SHEARON HARRIS NUCLEAR POWER PLANT, UNIT NO. 1
DOCKET NO. 50-400/LICENSE NO. NPF-63
CYCLE 14 CORE OPERATING LIMITS REPORT

SUMMARY OF CYCLE 14 COLR REVISIONS

Harris Unit 1 Cycle 14
Core Operating Limits Report - Rev. 01.0 CORE OPERATING LIMITS REPORT

Figure 2
Rod Group Insertion Limits Versus Thermal Power
(Three Loop Operation)

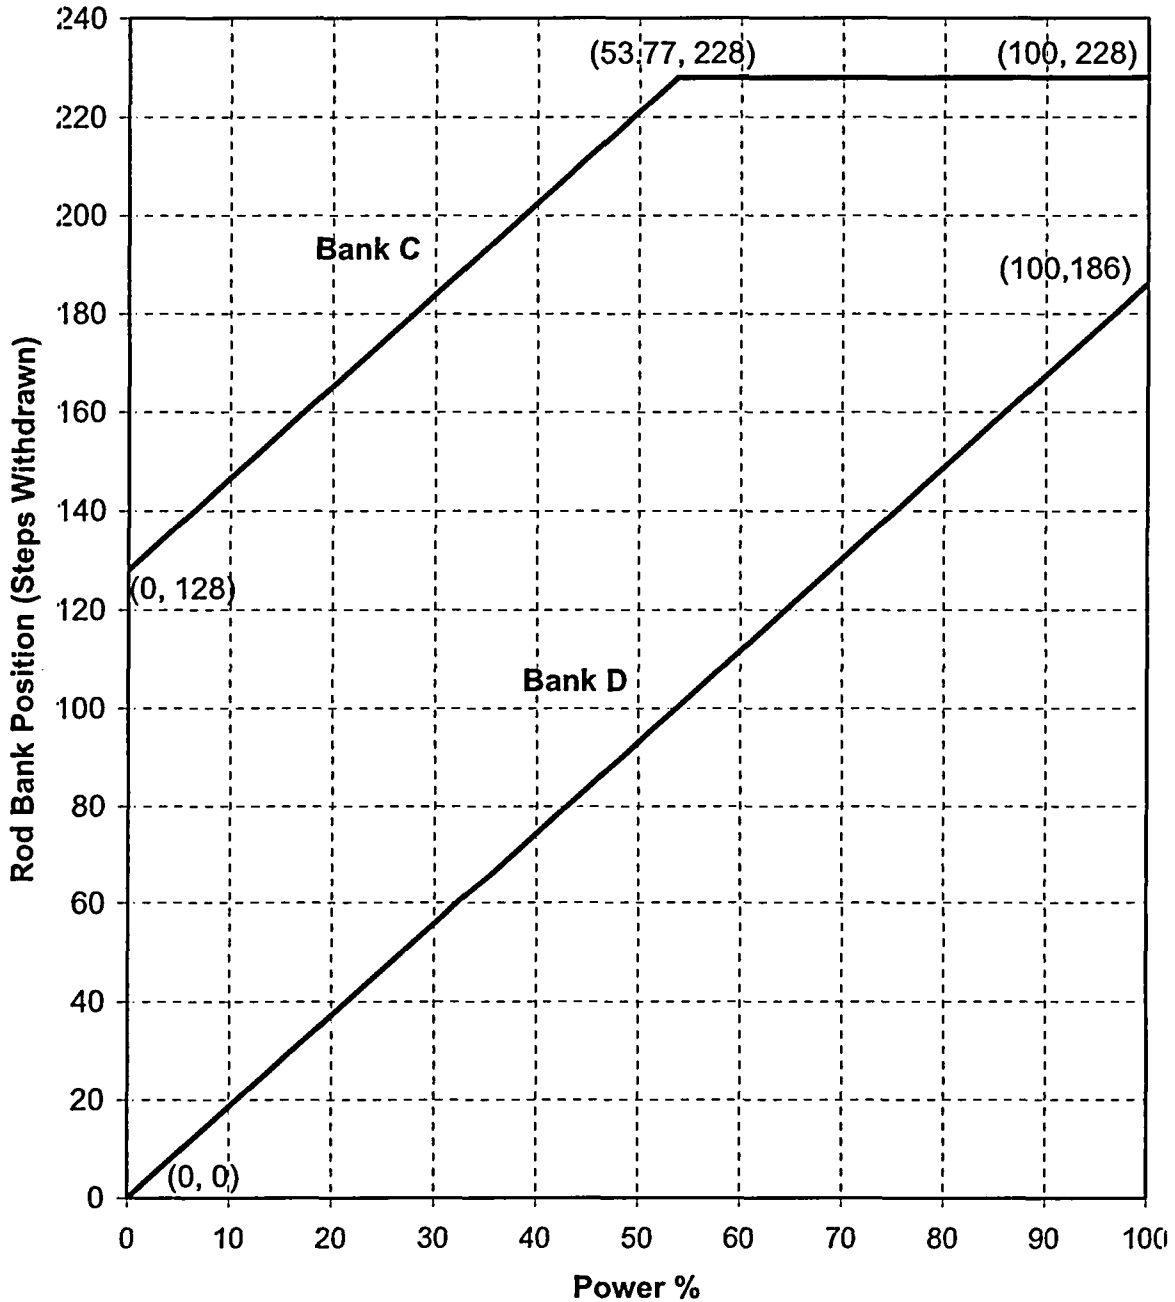
<u>Section</u>	<u>Description of Change</u>
	Cycle 13, Rev. 0 was revised to Cycle 14, Rev. 0 throughout the document.
2.2.2	The 300 ppm/ARO/RTP MTC limit was updated from -42.8 pcm/°F to -42.5 pcm/°F.
2.3	The Shutdown Rod Insertion Limit fully withdrawn for all shutdown rods was updated from 225 steps to 228 steps.
2.4	The Control Rod Insertion Limit fully withdrawn for all control rods was updated from 225 steps to 228 steps.
2.6.1.c	Added K(Z) applicability range.
2.6.2 and Figures 5-8	Change in V(Z) curves and applicability ranges.
2.7.b	Fdh limit changed from 1.66 to 1.64.
2.8	Refueling water boron concentration updated to 2181 ppm.
References 3.9 and 3.10	Updated with approved revisions to methodologies.
Figure 2	The Control Rod Insertion Limit fully withdrawn for all control rods was updated from 225 steps to 228 steps.
Figure 4	Added K(Z) applicability range.

- Notes:
1. Fully withdrawn position shall be 228 steps
 2. Control Banks A and B must be withdrawn from the core prior to power operation
